EASA	AIRWORTHINESS DIRECTIVE	
	AD No.: 2014-0015	
	Date: 14 January 2014	
Note: This Airworthiness Directive (AD) is issued by EASA, acting in accordance with Regulation (EC) No 216/2008 on behalf of the European Community, its Member States and of the European third countries that participate in the activities of EASA under Article 66 of that Regulation.		
This AD is issued in accordance with EU 748/2012, Part 21.A.3B. In accordance with EC 2042/2003 Annex I, Part M.A.301, the continuing airworthiness of an aircraft shall be ensured by accomplishing any applicable ADs. Consequently, no person may operate an aircraft to which an AD applies, except in accordance with the requirements of that AD, unless otherwise specified by the Agency [EC 2042/2003 Annex I, Part M.A.303] or agreed with the Authority of the State of Registry [EC 216/2008, Article 14(4) exemption].		
Design Approval Holder's Name: ALLSTAR PZL GLIDER Sp. z o.o.		Type/Model designation(s): SZD-50-3 "Puchacz" sailplanes

TCDS Number: EASA.A.312		
Foreign AD: Not applicable		
Supersedure: This AD supersedes Civil Aviation Office (CAO) of Poland AD SP-0052-2003-A, dated 22 July 2003.		
ATA 27	Flight Controls – Airbrake Co

*Sketch 1 – Previous version of airbrake torque tube:
a) without reinforcement; b) with a single reinforcement*

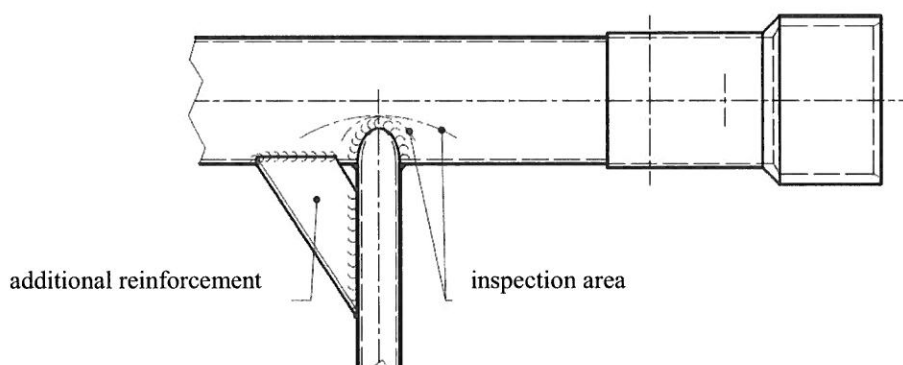
- for the gliders still equipped with the old version of torque tube, with or without reinforced corner, do as follows (see Sketch 1):
 - annually or during „100-hrs” inspection, in case of whichever occurs first, inspect the welded joint of airbrake torque tube, acc. to the description specified in item 2(b) of this SB;

- take the torque tube out of the fuselage, raising it up and forward.
3. Check the condition of torque tube in the area of welded joint with lever (as well as the additional reinforcing plates) – see the Sketch 1 or Sketch 2, dependently on the existing solution:

- Check with the 3 x min. magnifying glass for paintig cracks and tube's condition in the area of welded joint (also reinforcing plates), which could be an evidence of joint and/or tube cracking. If found the cracks of paint, remove coating and check the surface of tube. Fluorescent Penetrant Inspection (FPI) inspection may be done as an optional.

- Check the torque tube for permanent distortion of cylindrical tube's shape.

1. Cracks, permanent distortion of torque tube as well as corrosion pit on tube's inner side in the area of welded joint are not acceptable. In case of one of the defects listed above – replace the tube with the new one, purchased from Allstar PZL Glider – item no. 503.64.30.00A. The old tube may be released into service if no one of described defects exists.
2. Slight, uniform corrosive deposit should be removed with fine abrasive sand paper (grid 600 at min). If no corrosive pits are present on the surface, prevent inner area of the tube with anticorrosive agent (for ex. Fluidol) and release the tube into service. However, replacement the tube with the new one could be recommended.

Sketch 2 – New version of reinforced torque tube

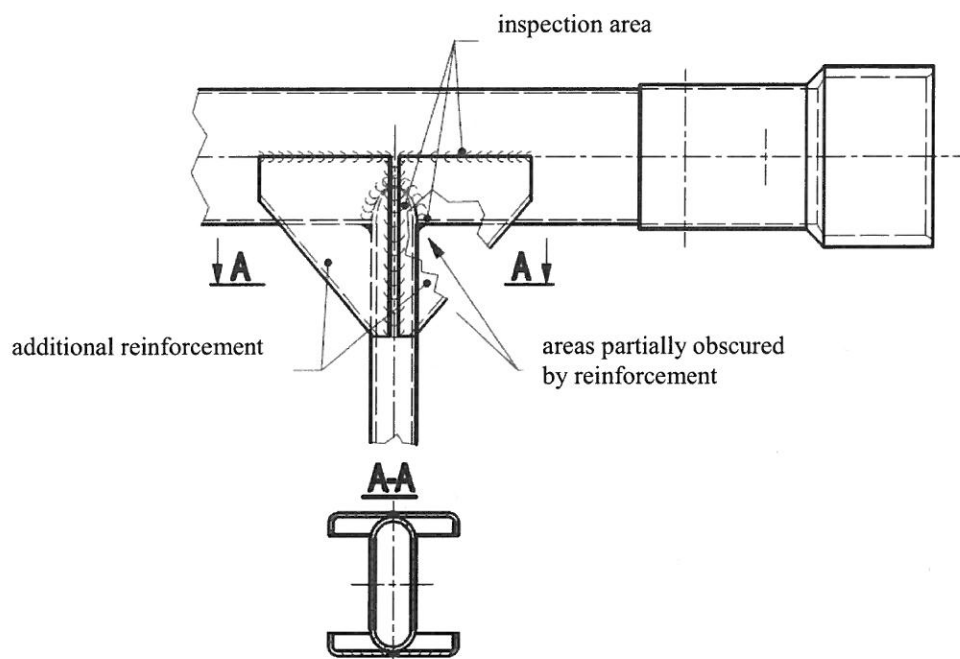
- for the gliders with the new type of torque tube with reinforced corners (see Sketch 2), i.e. the gliders from S/N 503.A.03.001 and up as well as others with the new type torque tube (see Sketch 2) do as follows:

- annually or during „100-hrs” inspection, whichever occurs first, check visually (disassembling of the tube from the fuselage is not necessary) the welded joint of the torque tube. Inspection of the areas partially obscured by the reinforcing plates is not required.

- during „1000-hrs” inspection check the welded joint of torque tube as described in 2(b) of this SB.

4. Check for evidence of corrosion of the inside welded joint area of torque tube.

Rys. 1 - Rury skrętne starego typu: a) bez wzmocnienia; b) z pojedynczym wzmocnieniem

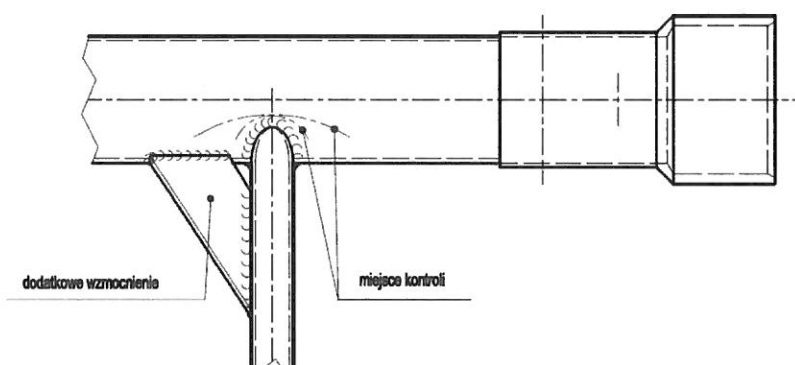
- dla szybowców nadal wyposażonych w rurę skrętną starego typu z dodatkowym wzmocnieniem naroża lub bez (patrz Rys. 1), należy:
 - wykonywać kontrolę połączenia spawanego dźwigni do rury skrętnej napędu hamulców, zgodnie z opisem w pkt 2(b), podczas każdego przeglądu rocznego lub „100-godzinnego”, w zależności co wystąpi pierwsze;

- unosząc rurę skrętną w górę i do przodu wyjąć ją z kadłuba.
3. Sprawdzić stan rury skrętniej w okolicy spoiny łączącej z dźwignią (oraz nakładkami wzmacniającymi naroża rura-dźwignia) – patrz Rys. 1 lub Rys. 2, zależnie od typu rozwiązania połączenia:

- Sprawdzić przy pomocy lupy o powiększeniu min. 3× czy nie występują pęknięcia lakieru i rury w okolicy spoiny (nakładek wzmacniających), co może świadczyć o pękaniu spoiny i rury. Jeżeli stwierdzono pęknięcia lakieru, usunąć lakier i badać powierzchnię pod lakierem. Sprawdzenia pod kątem pęknięć można wykonać również metodami penetracyjnymi;

- Sprawdzić czy nie występują trwałe odkształcenia cylindrycznego kształtu rury.

1. Pęknięcia, trwałe odkształcenia rury skrzywniej, jak również wżery korozyjne od wewnętrznej strony rury w okolicy spoiny są niedopuszczalne. Jeżeli którekolwiek z ww. uszkodzeń występuje – rurę skrzywną należy wymienić na nową, zakupioną w Allstar PZL Glider – element 503.64.30.00A. Rurę można użytkować dalej, o ile nie występuje żadne z ww. uszkodzeń.
2. Niewielki równomierny nalot korozyjny należy usunąć drobnym papierem ściernym (o ziarnistości min. 600). Jeżeli powierzchnia nie posiada wżerów, rurę – po zabezpieczeniu wnętrza środkiem antykorozyjnym (np. fluidolem) – można eksploatować dalej. Zaleca się jednak wymianę rury na nową.

Rys. 2 - Rura skrzywna nowego typu, wzmocniona

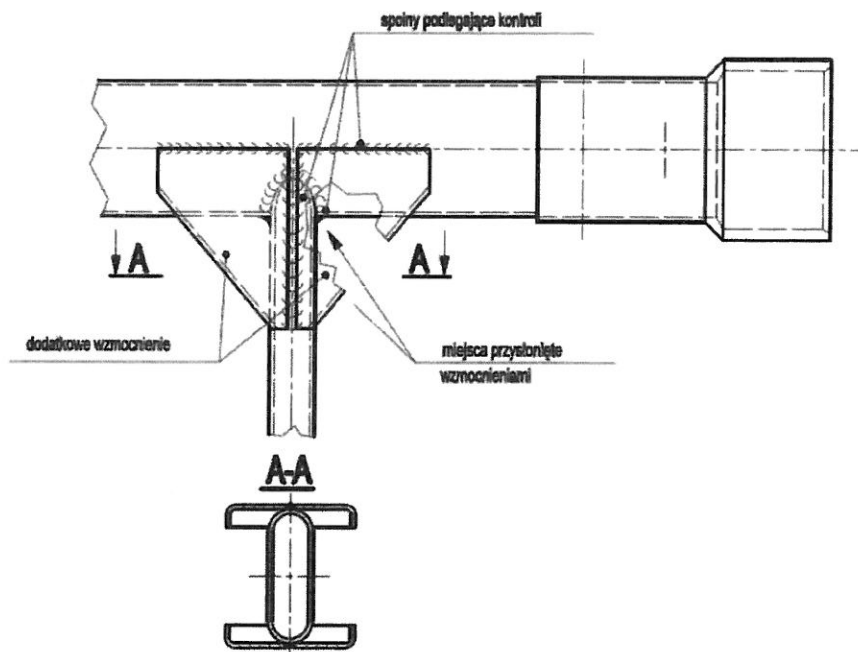
- dla szybowców, na których zabudowano rurę skrętną nowego typu ze wzmocnionymi narożami dźwignia-rura (jak na Rys. 2), tzn. szybowców o numerach fabrycznych od S/N 503.A.03.001 wzwyż oraz wyprodukowanych wcześniej, na których wymieniono rurę na rurę nowego typu (patrz Rys. 2), należy:

- wykonywać kontrolę wzrokową (bez konieczności demontażu rury z kadłuba) połączenia spawanego dźwigni do rury skrętnej napędu hamulców podczas przeglądu rocznego lub „100-godzinnego”, w zależności co wystąpi pierwsze. Nie jest wymagana kontrola miejsc przysłoniętych wzmocnieniami.

- wykonywać kontrolę połączenia spawanego dźwigni do rury skrętnej napędu hamulców, zgodnie z opisem w pkt 2(b) podczas każdego przeglądu „1000-godzinnego”.

4. Sprawdzić czy we wnętrzu rury skrzywniej, szczególnie w rejonie połączenia spawanego, nie występują ślady korozji.
